Addendum #1

Project Name:	Island Grove Event Center Lighting Upgrade
Bid Number:	RFP #FD20-06-107
Date:	July 10, 2020
Manager:	Dale Blehm / Jimmy Trujillo

Item 3	Drawing Clarifications - see attached drawings. - drawings E100 and E700 updated with job walk notes - replace existing E100 an E700 - notes on E100 and E700 supercede notes on entire drawing set - added detailed coordination drawing for owner supplied fixture type SB - drawing SB 01 with clarifications based on walk thru discussions.

SB 01

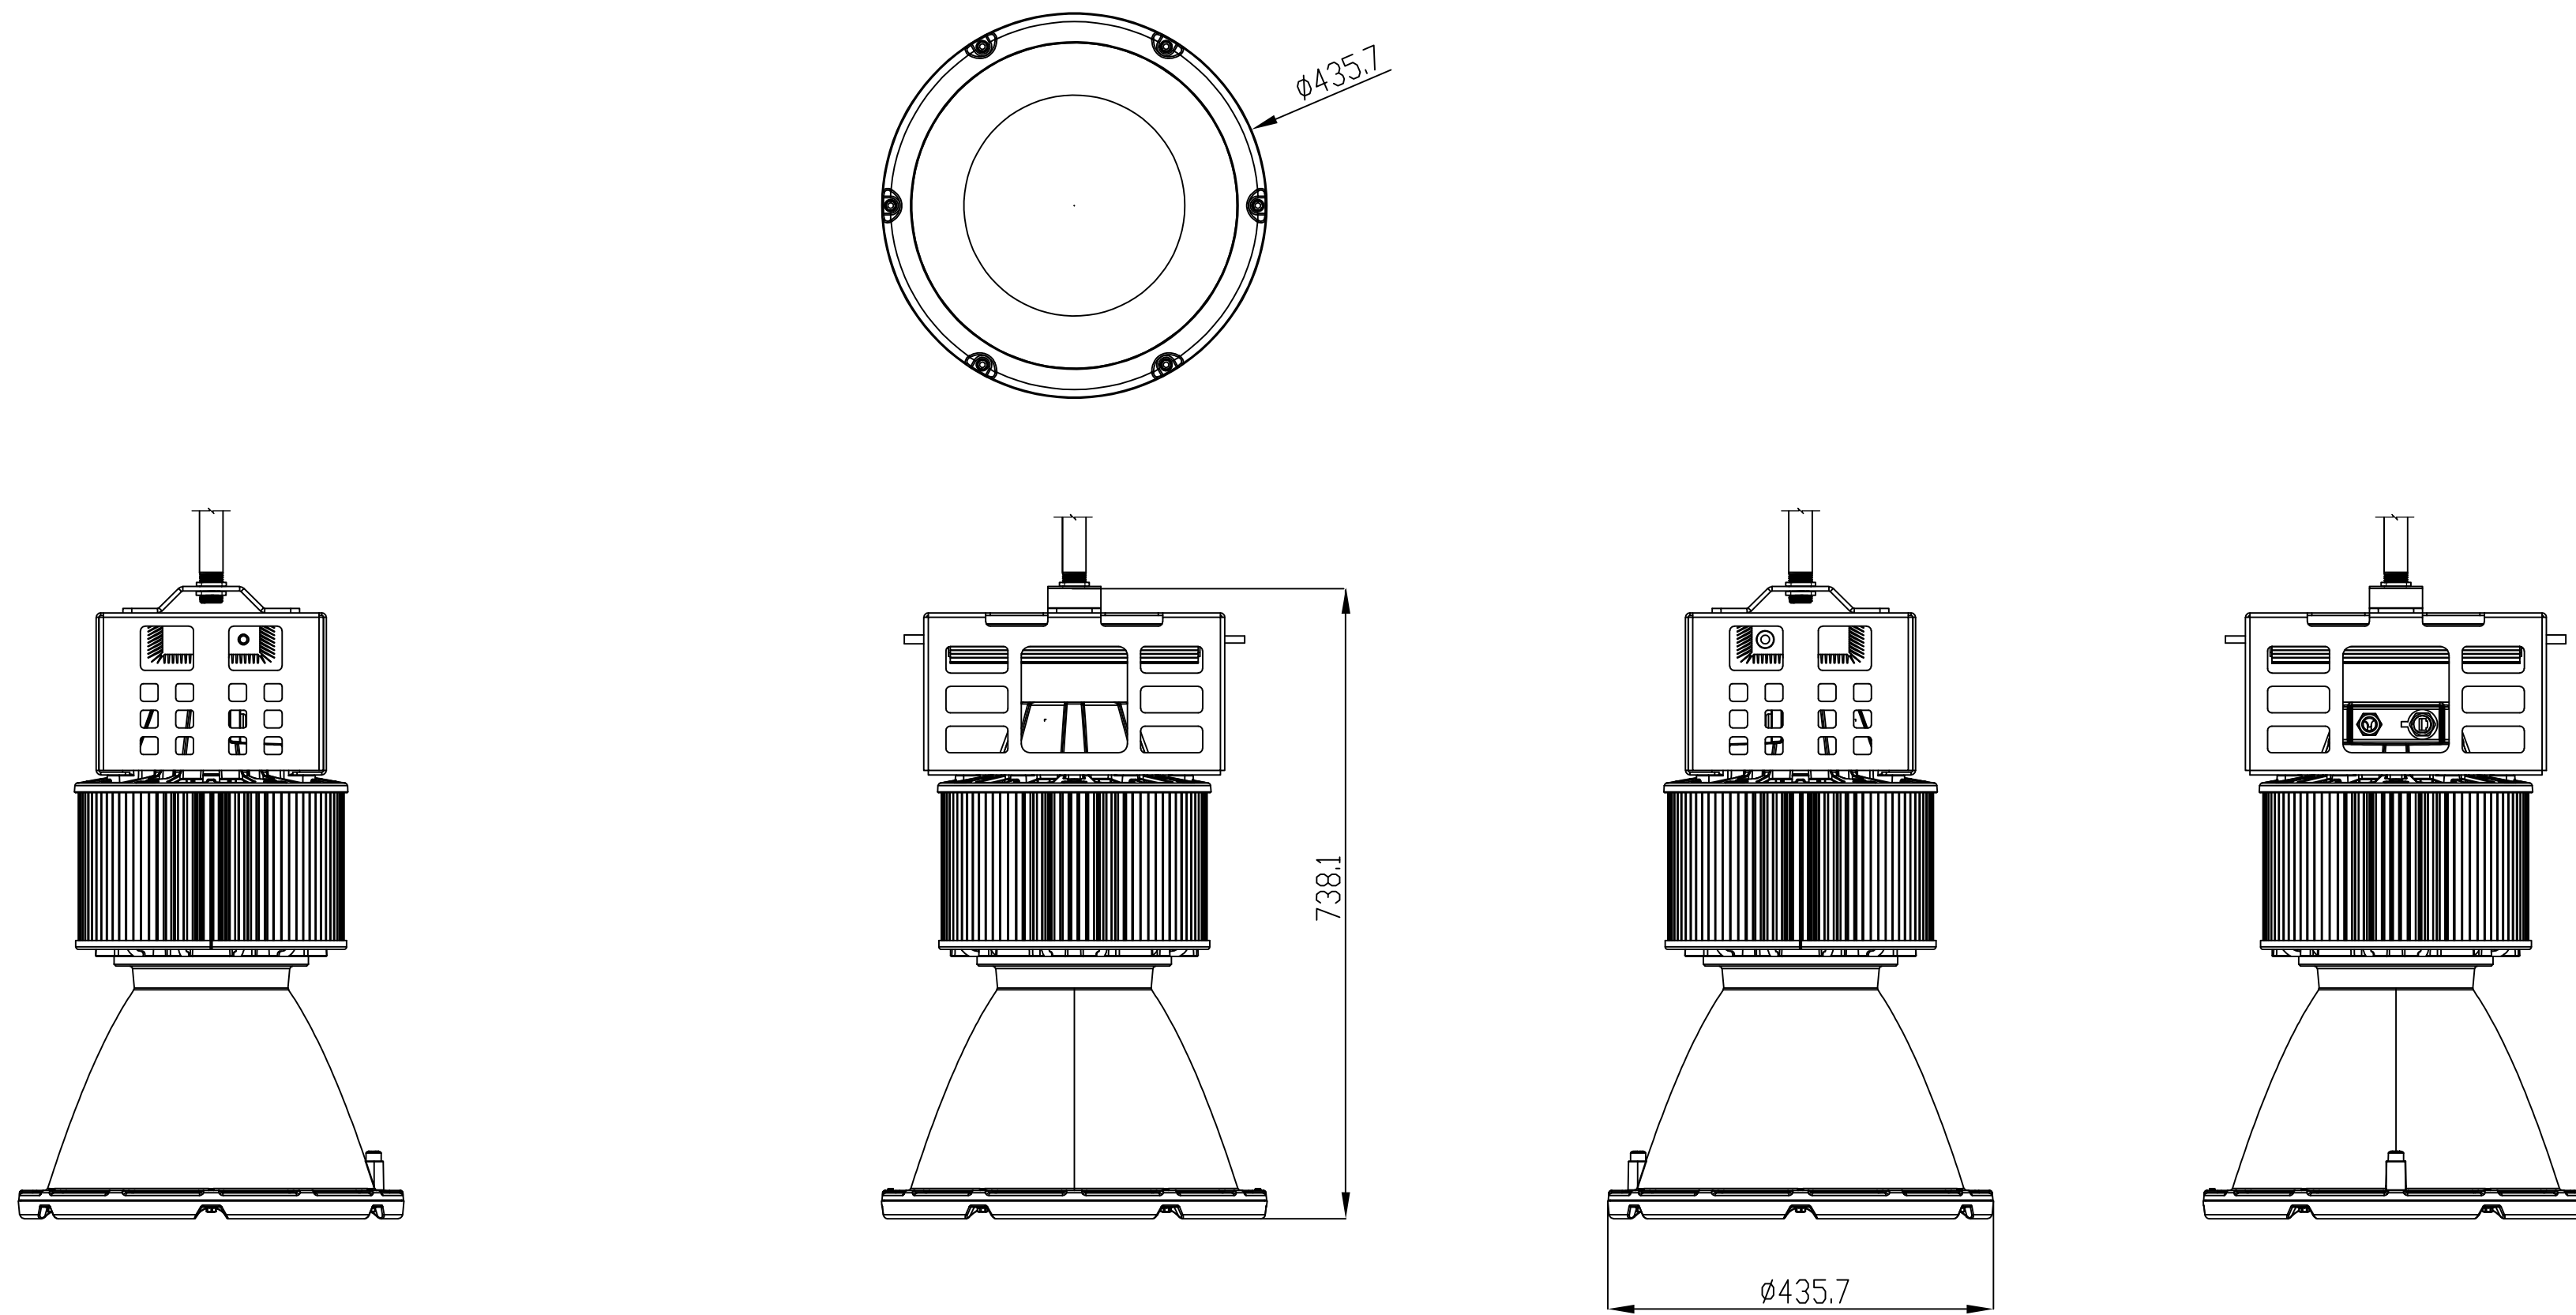
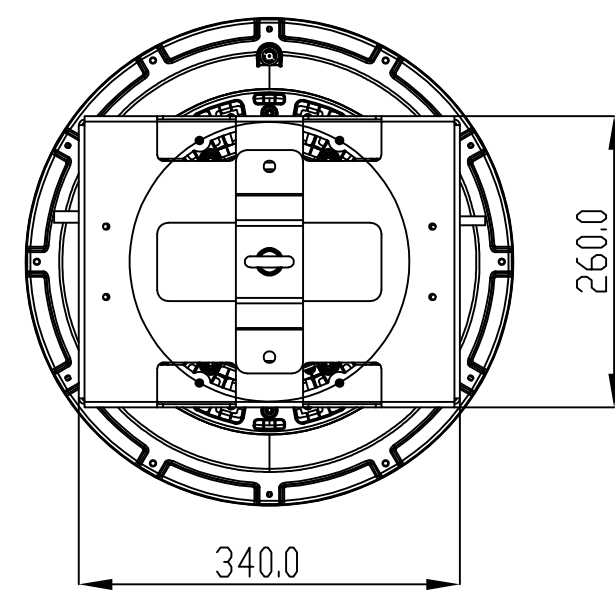
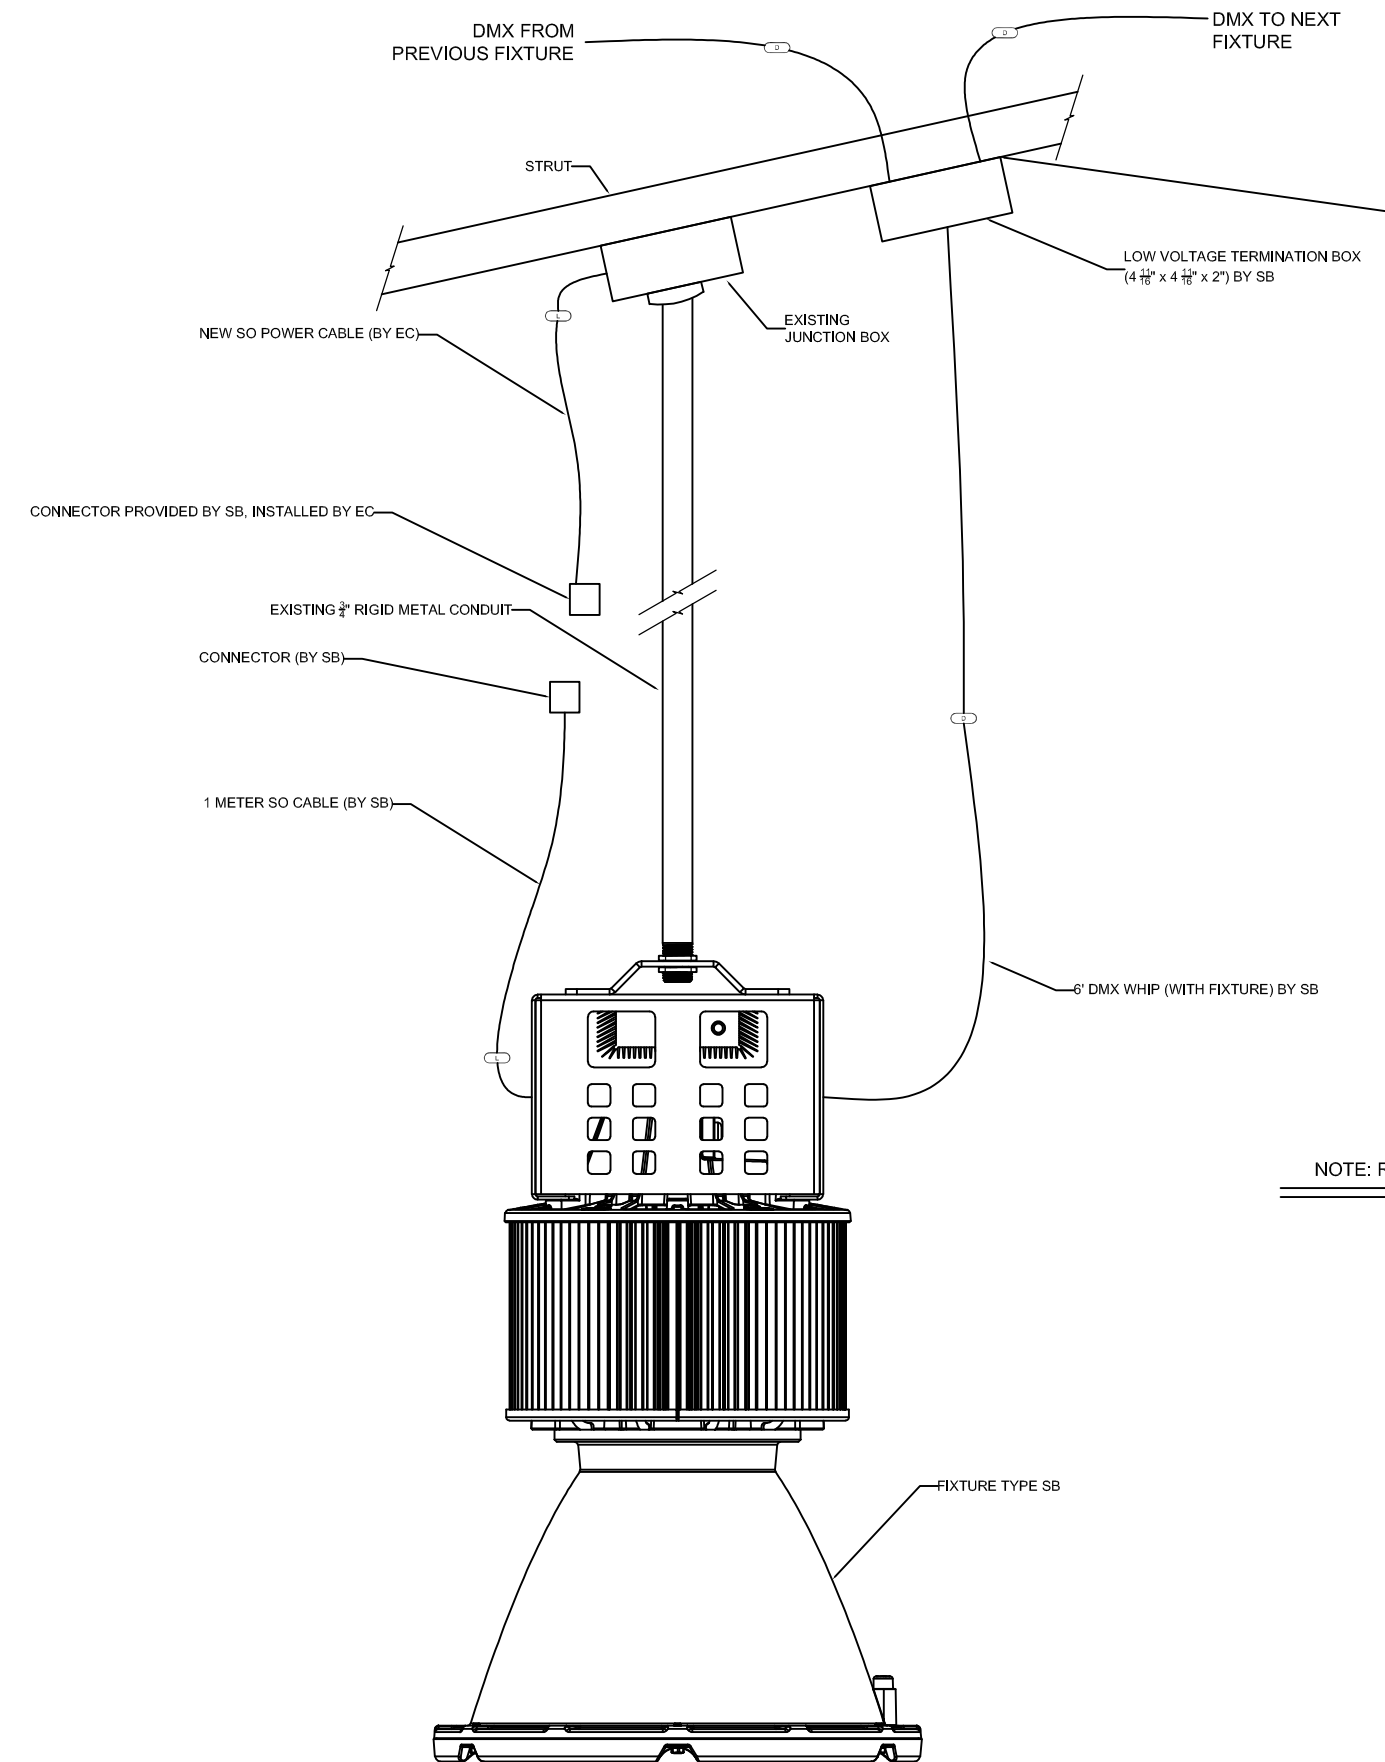
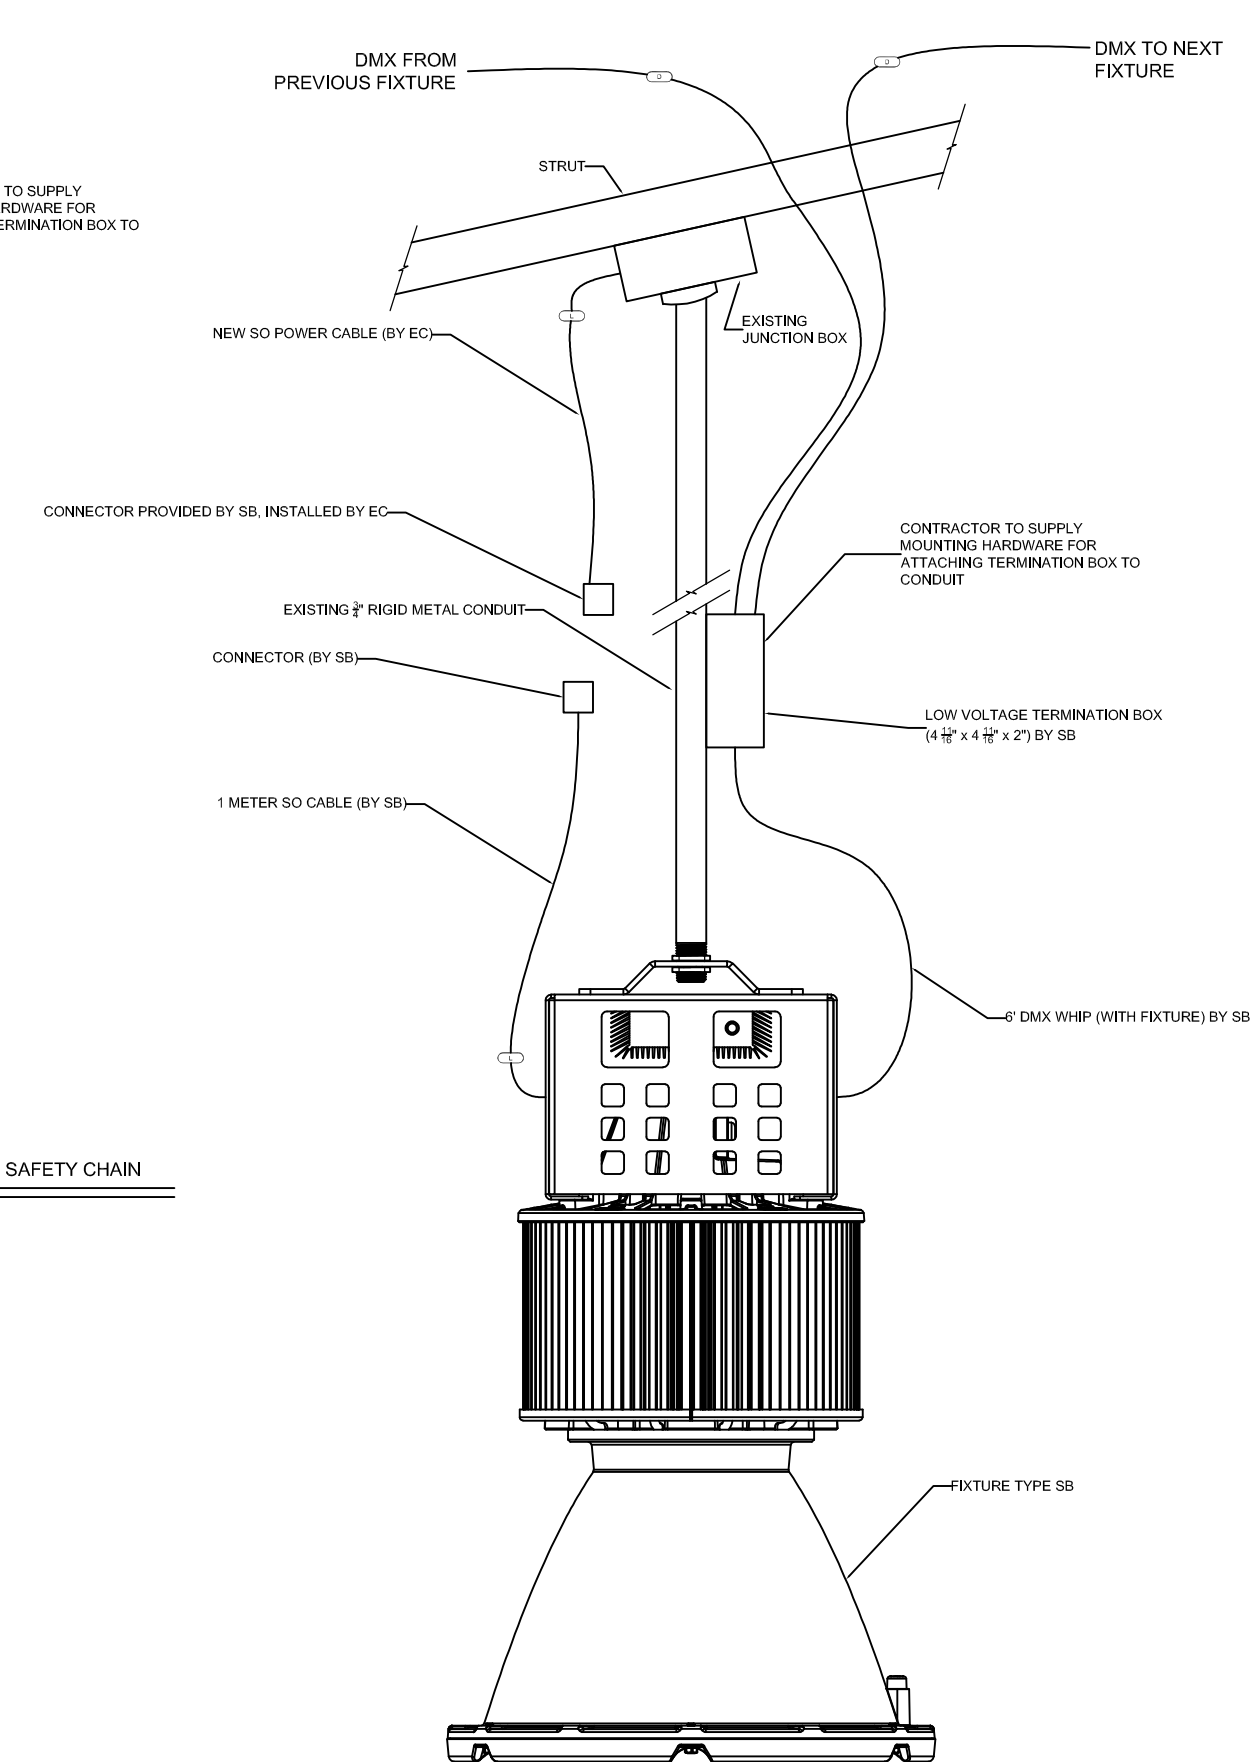
Item 8	RFP states, The City of Greeley has purchased the Sport Beam fixtures (SB) in order to have them before the start of the project. Yes.
Item 9	Did the city of Greeley purchase all required DMX control wire and DMX term box for (SB) fixtures? See Addenda and new drawing SB 01. Low Voltage data wire (all types) is supplied by the installing Electrical Contractor.
